Application No.: 10/091,398

For: IN-LINE PHASE SHIFTER

In response to the Office Action mailed August 12, 2003, please amend the above-identified application as follows:

AMENDMENTS TO THE SPECIFICATION:

Fig. 1

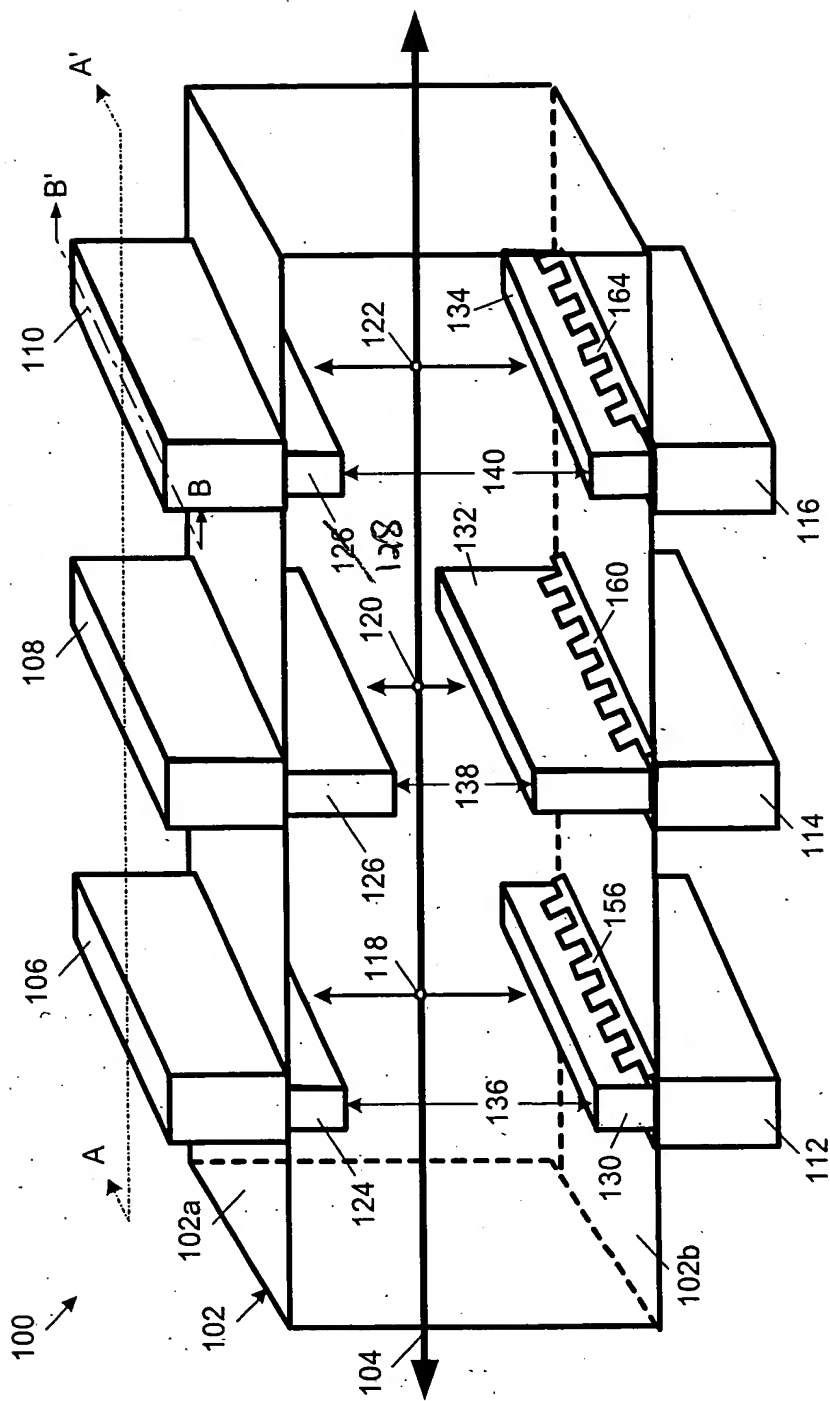
The attached sheets of drawings includes changes to Figs. 1 and 4. These sheets, which include Fig. 1 and Fig. 4, replace the original sheets including Fig. 1 and Fig 4. In Fig. 1, reference item 126 under reference item 110 has been changed to --128-- to correct a typographical error. (See paragraph [0022].) In Fig. 4, the reference character --400-- has been added, as required by the Examiner on page 3 of the Office Action and described in paragraph [0022] of the Office Action. Also in Fig. 4, "Zin" has been replaced by "Yin" because the figure shows admittance along the waveguide path 404, as described in paragraph [0025] of the specification.

Please replace the original drawing sheets, which include Fig. 1 and Fig. 4, with the new attached sheets including Fig. 1 and Fig.4.

Fig. 4

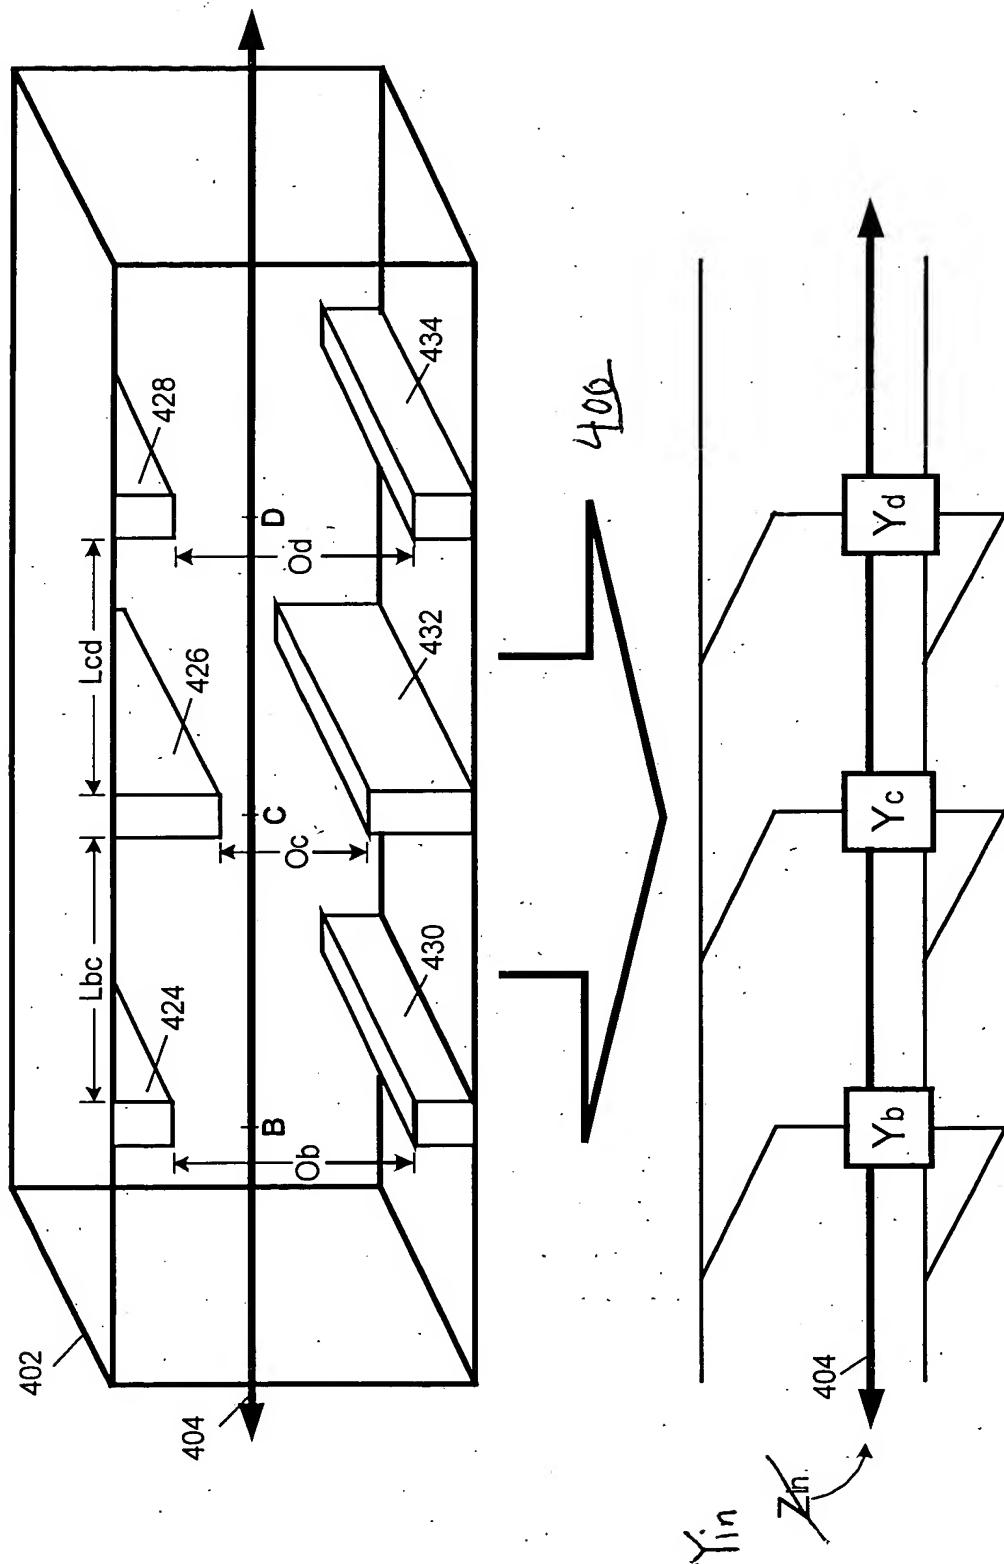
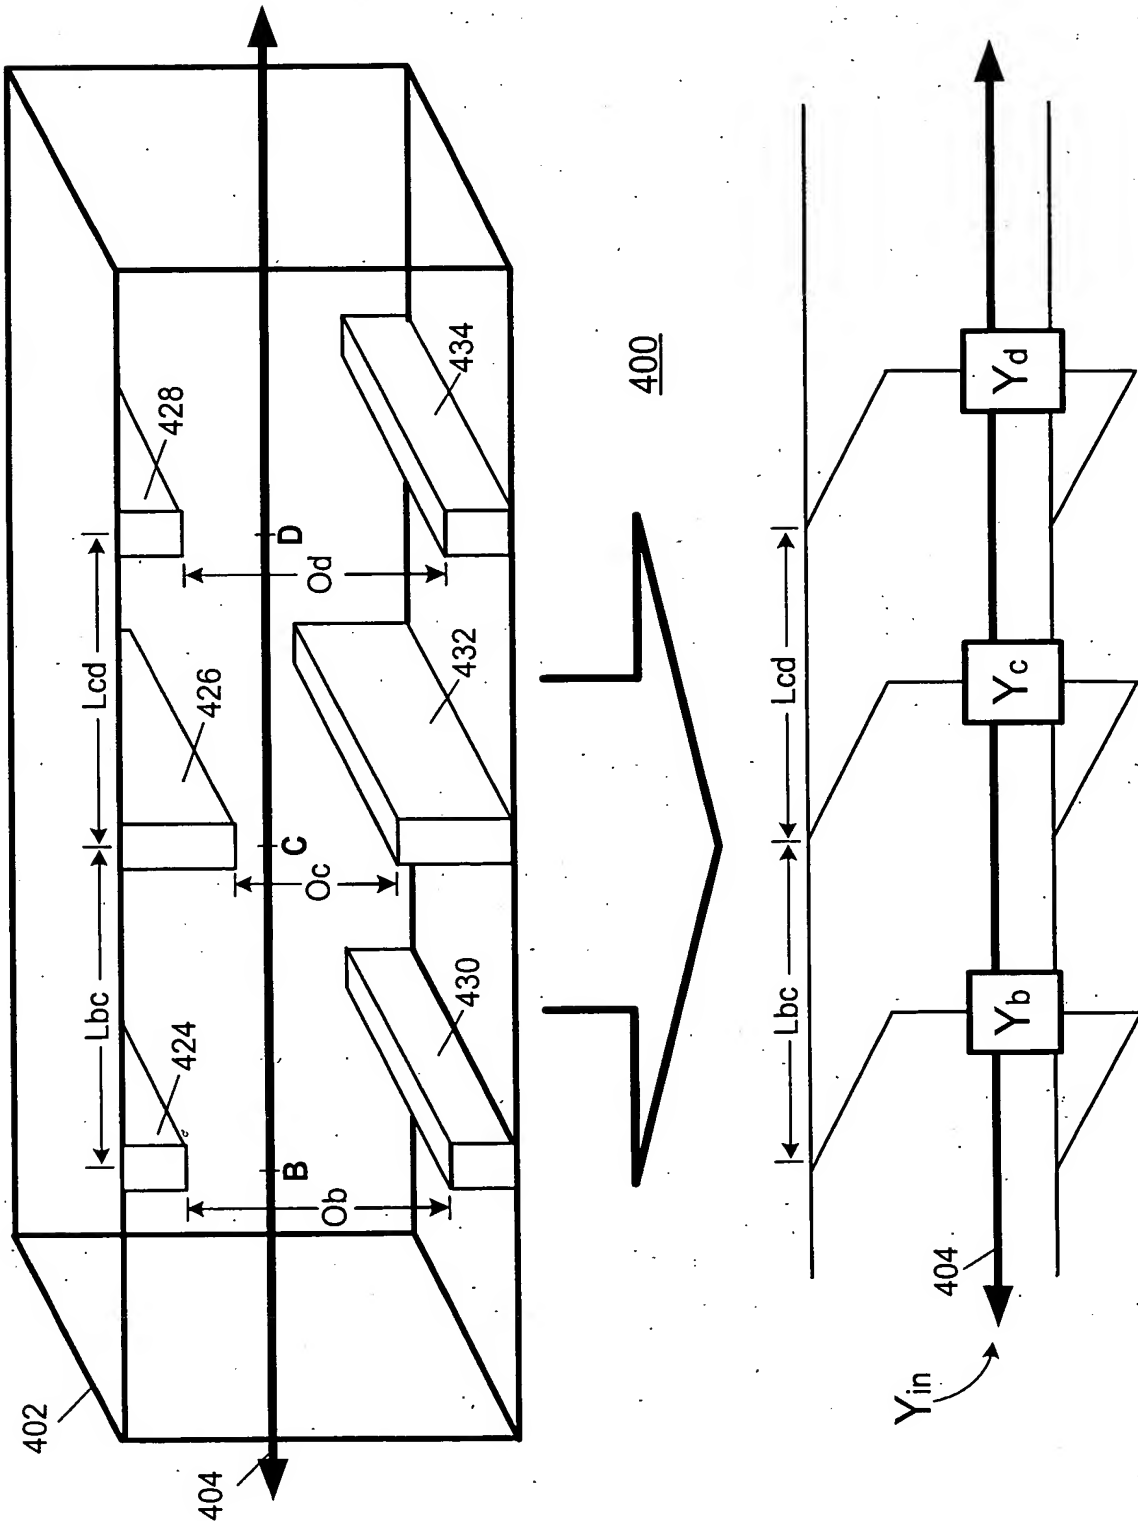
On page 3 of the Office Action, the Examiner notes that the reference labels Zin, Yb, Yc, and Yd, as depicted in Fig. 4, are not explicitly described in the specification. In response, paragraph [0025] of the specification has been amended to provide explicit description for the admittances Yb, Yc, and Yd shown in Fig. 4. The present response also includes proposed drawing changes in which the item "Zin," as shown in Fig. 4, has been changed to an admittance "Yin." Support for this change is found in original paragraph [0025], which describes an admittance "Y" along the waveguide path 404.

The Office Action includes an objection to the drawings because Fig. 4 does not show reference labels "400," "Y" and "L." In response, Applicants submit herewith proposed drawing change to Fig. 4 that includes the reference labels "400" and "Yin." As noted above,

Applicants' proposed changes to Fig. 4 include replacing "Zin" with "Yin" and have amended the reference "Y" to "Yin" in the specification because the original specification describes Fig. 4 as showing admittance along the waveguide path 404. Applicants have removed the reference to "L" in the specification because it is believed that the description in paragraph [0025] of separations between openings refers to the exemplary separations "Lbc" and "Lcd" would render redundant such inclusion of an additional label "L."
